File No. 250775

1 [Memorandum of Agreement - City of Daly City - Vista Grande Drainage Basin Improvement
2 Project - Not to Exceed \$35,000,000]

3 **Resolution approving and authorizing the General Manager of the San Francisco Public**
4 **Utilities Commission to execute, on behalf of the City and County of San Francisco, a**
5 **Memorandum of Agreement with the City of Daly City for the funding, construction, and**
6 **operation of the Vista Grande Drainage Basin Improvement Project, for a not to exceed**
7 **amount of \$35,000,000, with a duration of five years starting August 4, 2025, through**
8 **August 31, 2030, pursuant to Section 9.118 of the Charter.**

Figure 2-4b
Modified Fort Funston Work Area

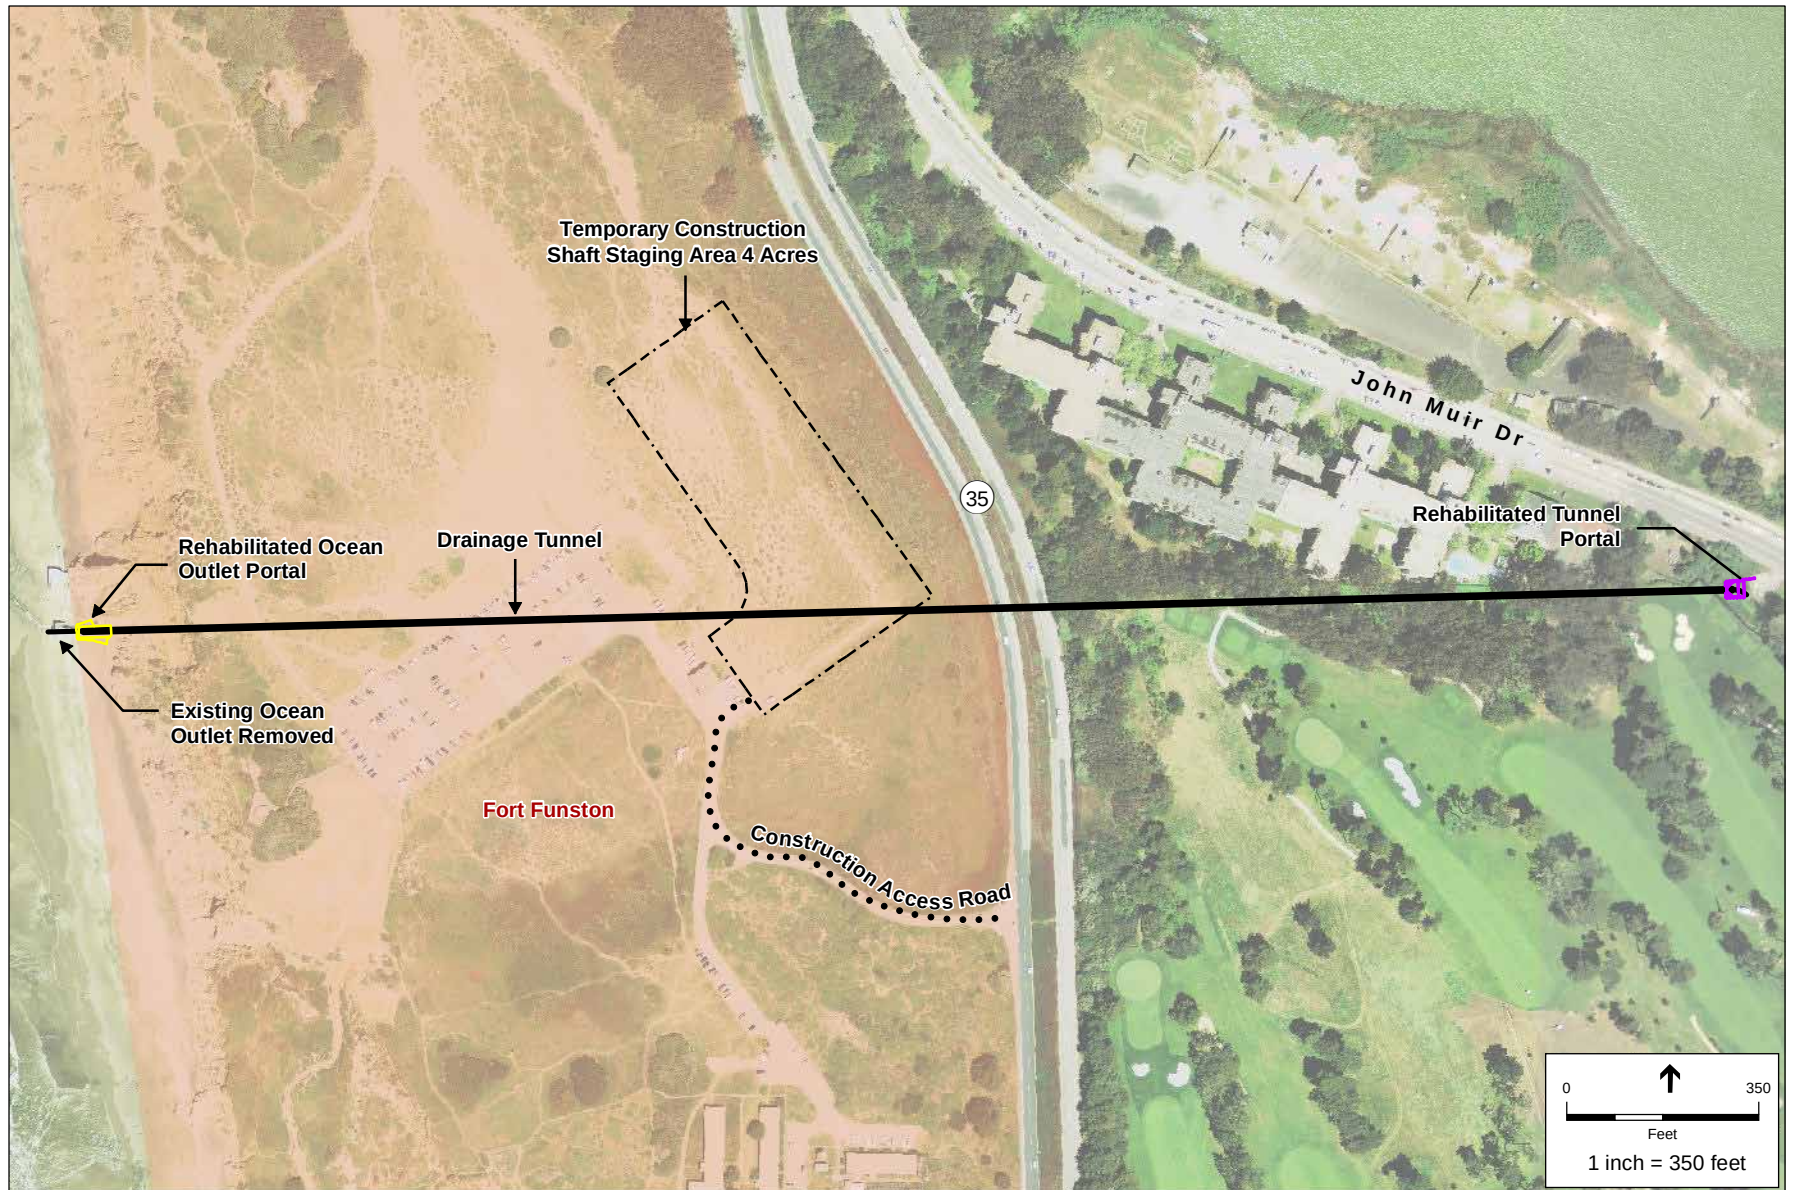
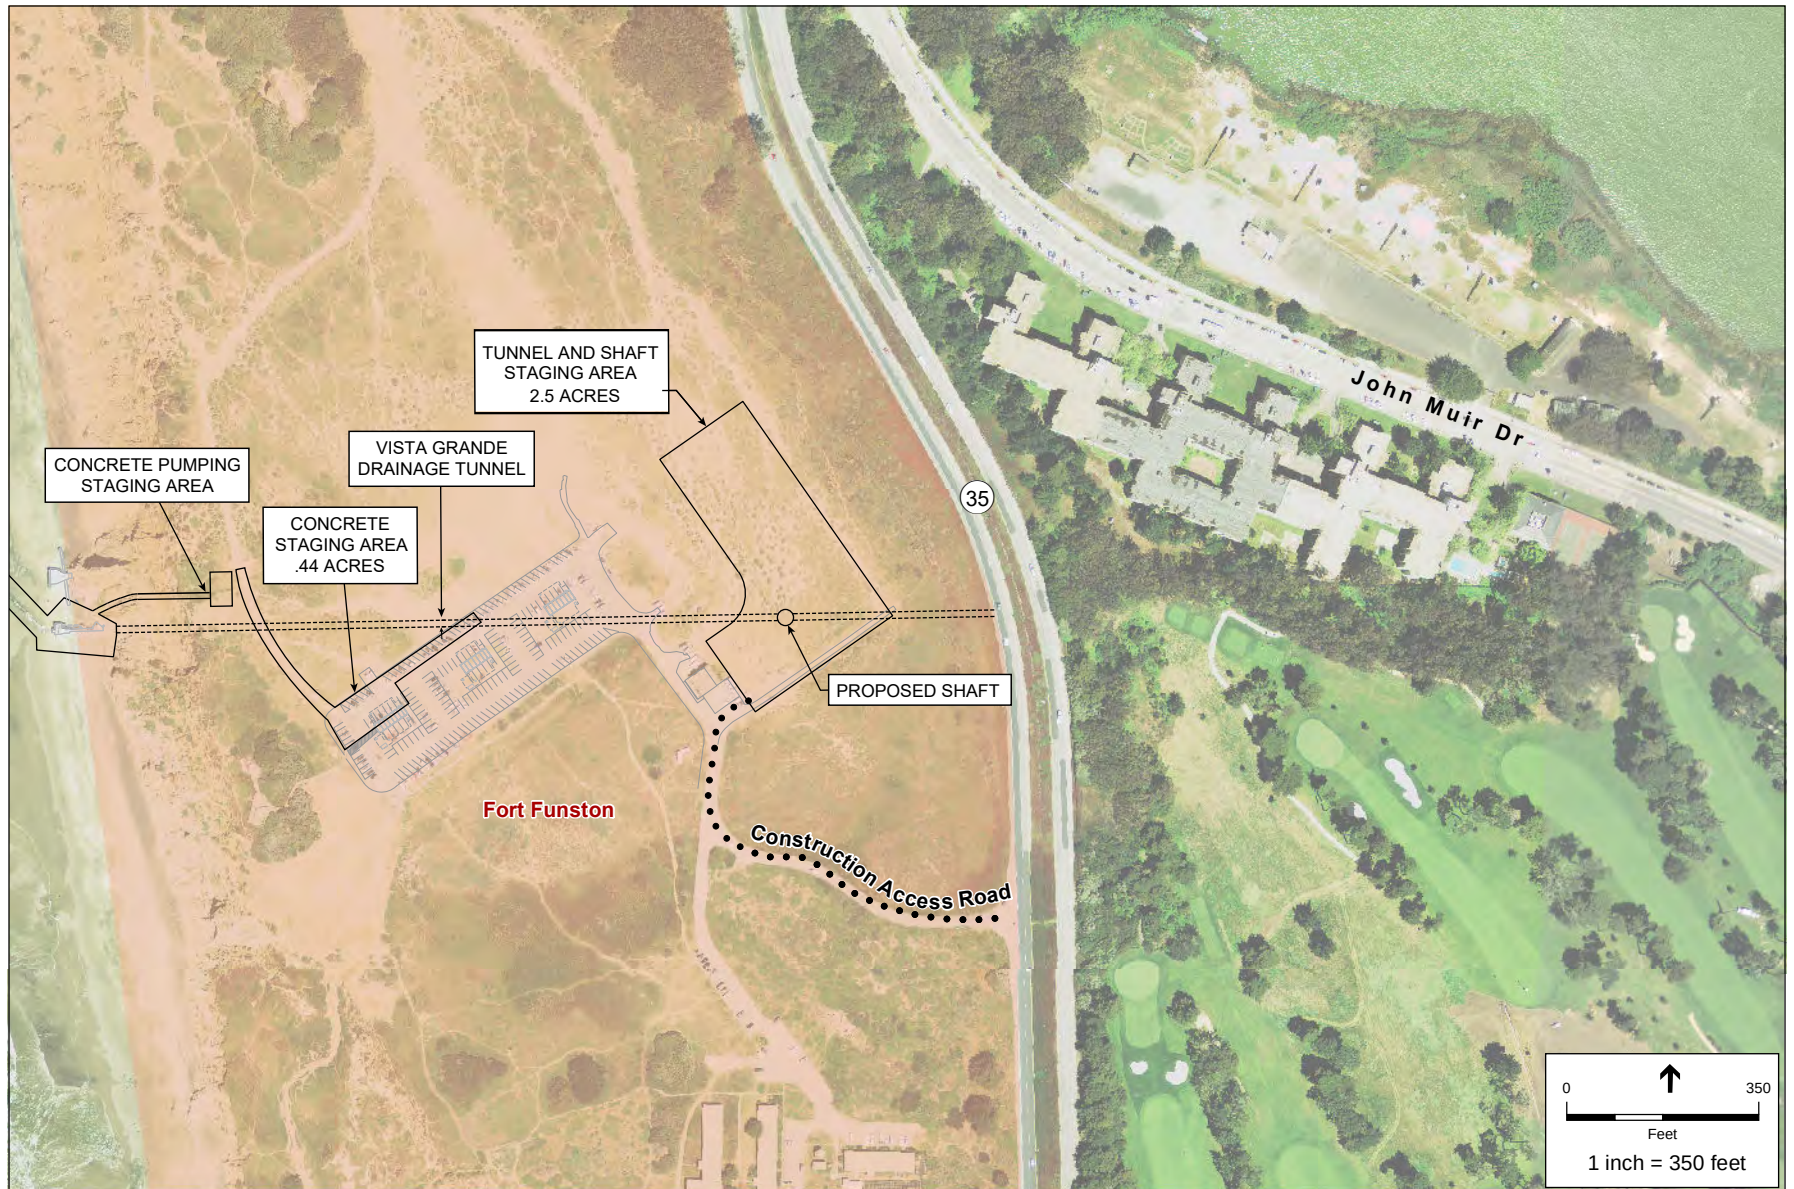
After certification of the EIR/EIS, modifications were made to the Project design. Under the Modified Project, the Fort Funston work area would be reduced to 2.5 acres, 1.5 acres smaller than originally estimated (see **Figure 2-4b**). The proposed modifications also include a new temporary work area located within the Fort Funston parking lot, 400 feet southwest of the Fort Funston tunnel and shaft work area.

The new work area would be 0.44 acre and would be located in the northwest corner of the Fort Funston parking lot. The work area would be used for concrete fabrication work, with access from Fort Funston Road off Skyline Boulevard. Concrete fabricated at this work area would then be moved to the concrete pump work area to the west, located along the top of the bluffs above the Ocean Outlet location on Funston Beach.

Figure 2-5b
 Modified Ocean Outlet Design

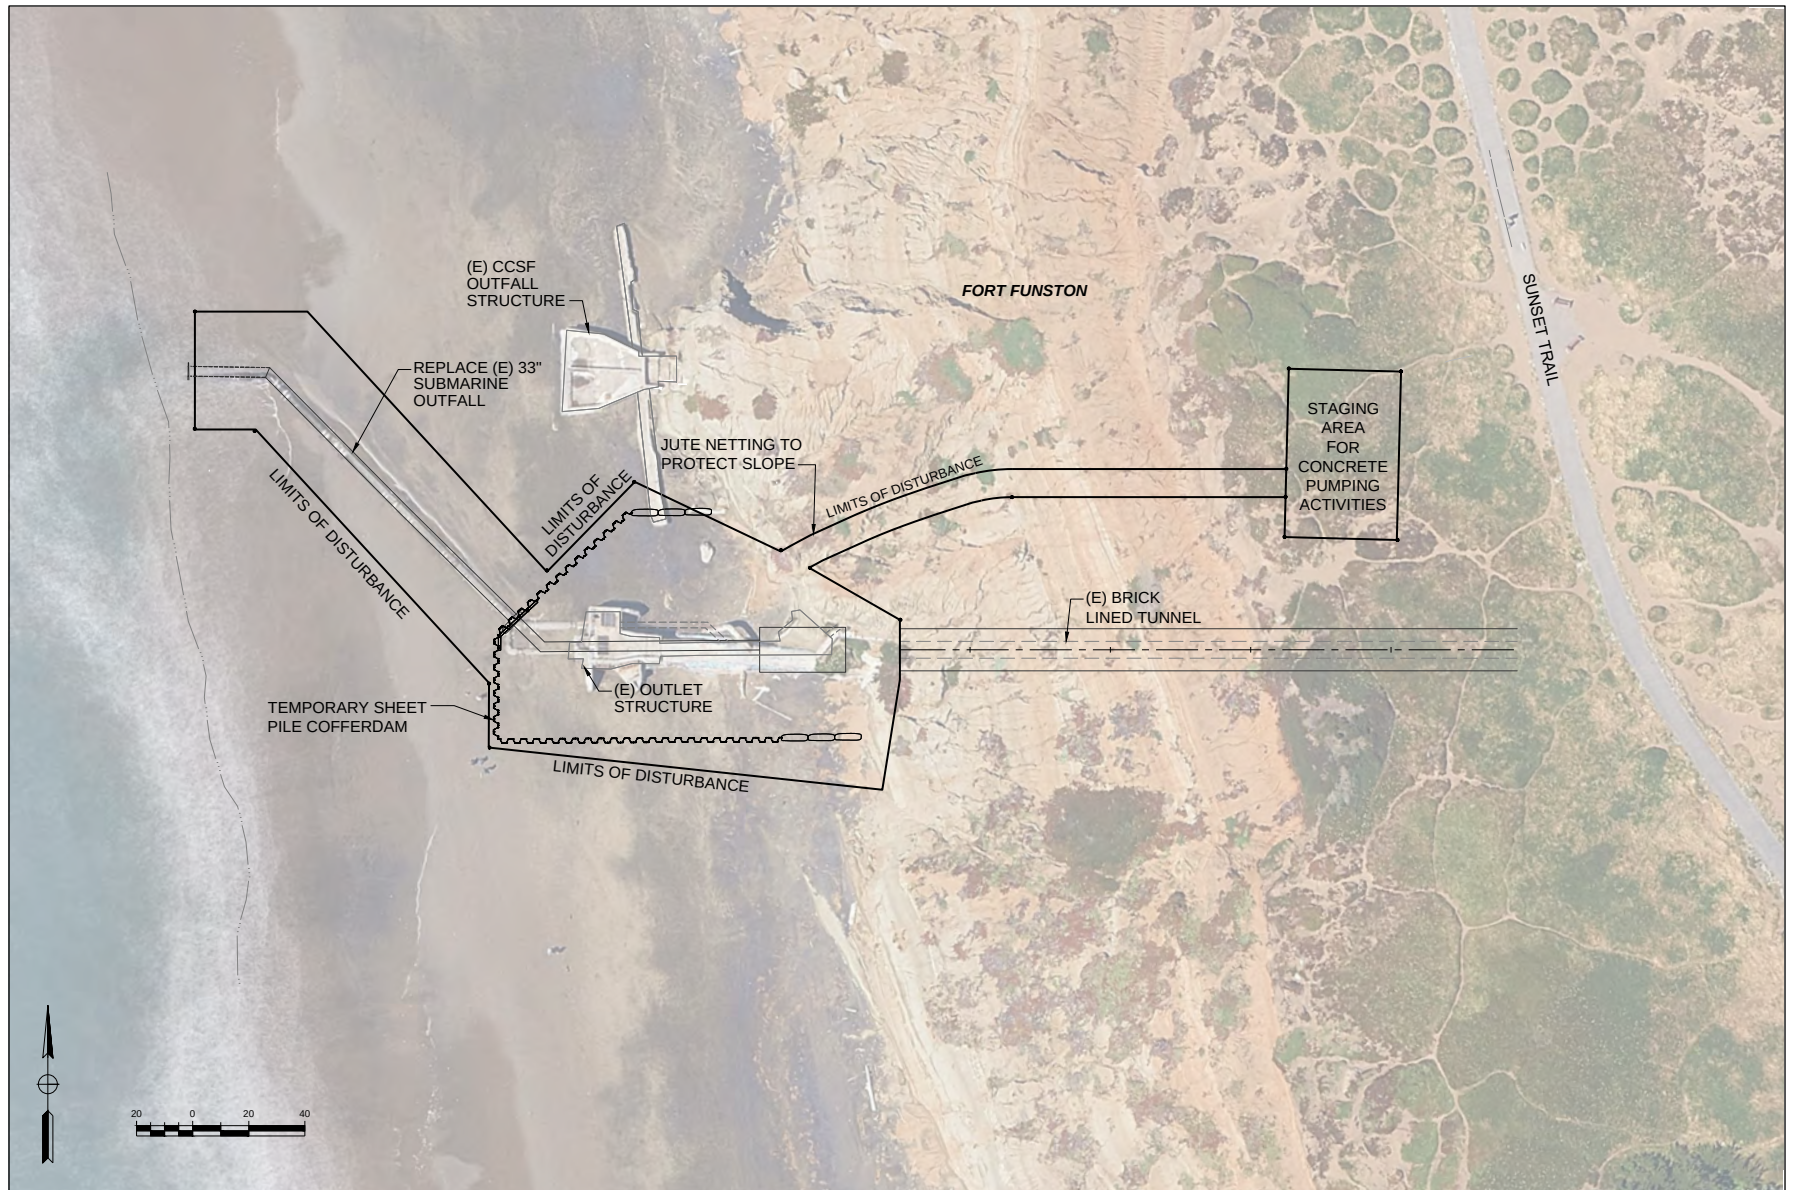
The design of the proposed Ocean Outlet structure, including the wing walls, considers the effects of sea level rise on both the operation of the outlet and the rate of cliff erosion. However, the Coastal Commission concluded that the two wing walls were not permissible as part of Project design. Thus, under the Modified Project, the wing walls would be removed from the final design of the Ocean Outlet (see **Figure 2-5b**).

There would also be other small changes to the design elements shown in the EIR/EIS, including additional supports for the anchor outfall pipe. Additionally, the work area for concrete pumping activities and the overall layout of the disturbed area for construction activities at the Ocean Outlet location would move just north of the disturbed area shown in Figure 2-5a (see Figure 2-5b for comparison). Jute netting would be laid on the cliff face to protect it from any disturbance from concrete pumping activities. After the completion of construction at the Ocean Outlet location, excavations would be backfilled and disturbed areas would be regraded with native soils to match existing profiles.

Under the Modified Project, the 70-foot and the 100-foot wing walls would be removed from the final design of the Ocean Outlet (see Figure 2-5b). There would also be other small changes to the design elements shown in the EIR/EIS, including additional supports to the anchor outfall pipe. The work area for concrete pumping activities and the overall layout of the disturbed area for construction activities at the Ocean Outlet location would move just north of the disturbed area shown in Figure 2-5a. However, beach access for recreationists would be maintained and temporary avoidance or restrictions would be in place only when vehicles and equipment are being transported along the beach and during the construction of the portion of the submarine outfall pipeline.
